Permit of Authorization to Construct an On-Site Sewage Facility Permit Valid For One Year From Date Issued

Permit Number: 118670
Issued This Date: 06/24/2025
This permit is hereby given to: Robert Potosky

1101 WHITE WATER RD
NEW BRAUNFELS, TX 78132

RE- Septic Design Revision for Permit# 118670

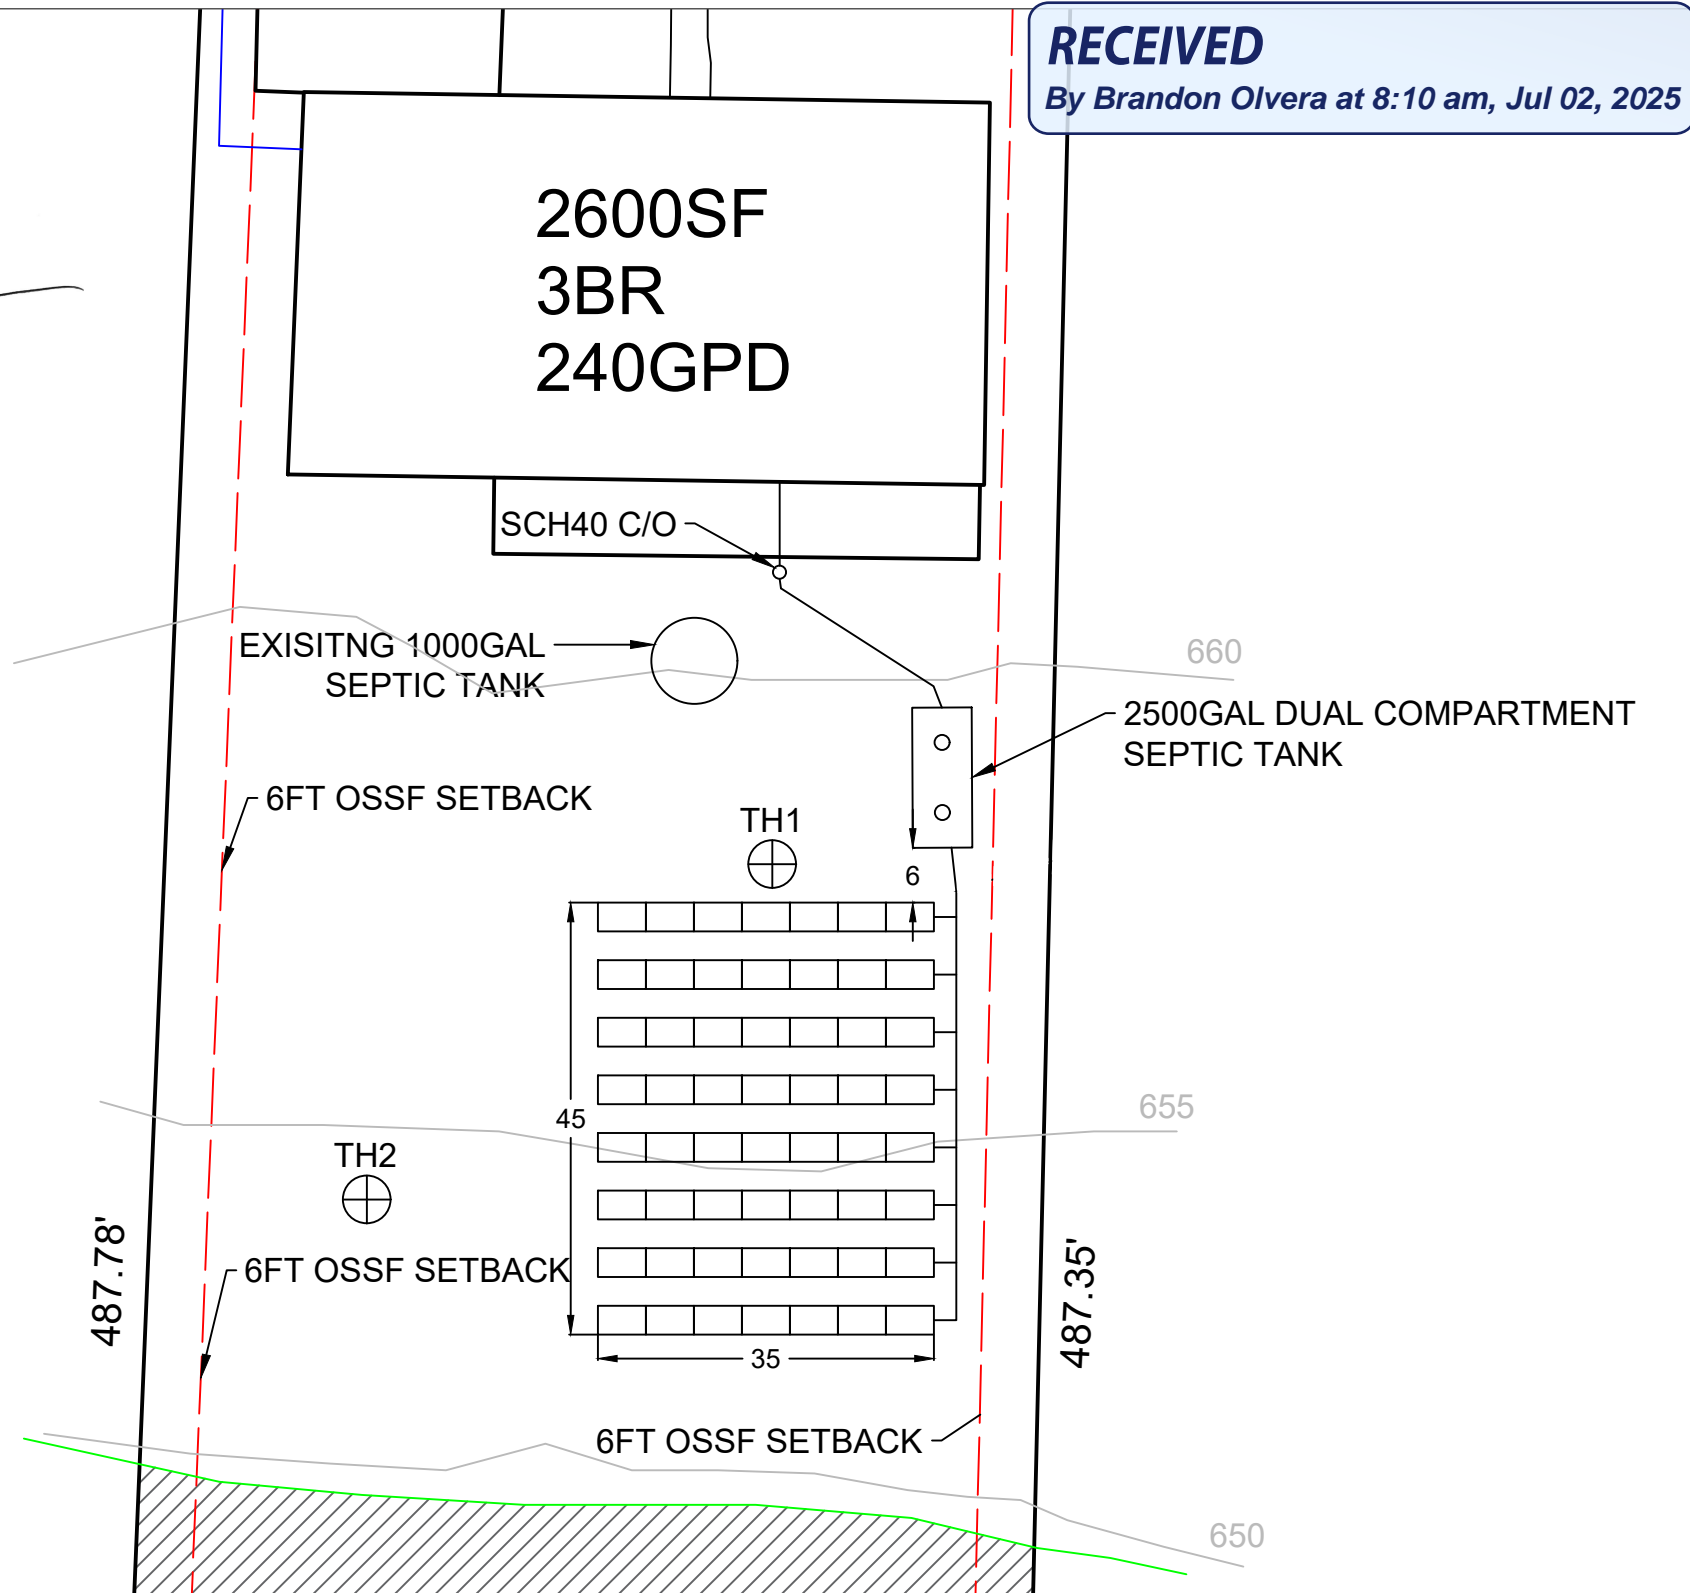
a. The gallons per day (GPD) purposed is below the minimum requirement for a 3-bedroom home greater than 2500 sq. ft.

b. 285.91(2) the GPD would need to be designed for 300.

a. Potable waterlines state a 9 ft separation distance referenced in TAC 290. The OSSF rules in 285 states there is a 10 ft separation distance. If you want to use the 9 ft separation distance, this will need to be in the form of a variance request.

b. Indicate depth your trenches will be.

3. The actual amount of absorption area differs depending on the planning materials and the site plan and the application.

a. The calculations I am getting based on the design are 1572 sq. ft. including the ends or 1300 sq. ft. not including the ends.

GPD has been revised to 300gpd

10ft Separation Distance to Water lines corrected

Trench Depth shown under "materials" in planning materials for 18-36 inches

The absorption area calculations have been corrected to 1300 square feet (without end caps)
